North-South Cycle Superhighway (CS6) Stonecutter Street to King's Cross

Response to issues raised
September 2016

Taxi / parking / loading bays on the inside of the cycle track

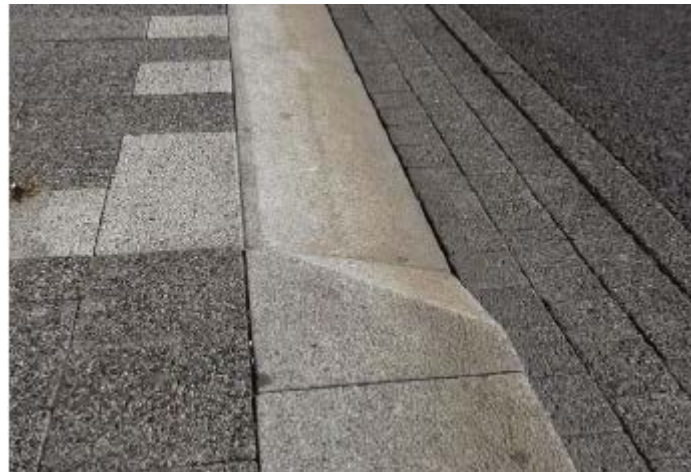
There was concern raised about the placement of parking, loading and taxi bays behind the stepped cycle track on Farringdon Street as vehicles will cross the cycle lane to reach the bays.

There are a number of unsignalised side roads along this stretch of the route. The cycle track is positioned in front of the bays so that it is in full view for main road traffic (rather than being behind the parking bays). This is because cyclists will be travelling at a similar speed to motor traffic along Farringdon Street and vehicles turning into the side roads to the east will have good visibility of the track and any cyclists on it. Vehicles turning out of the side roads will be encouraged to slow down with raised junction treatments and will have good visibility of cyclists over the motorcycle and taxi parking.
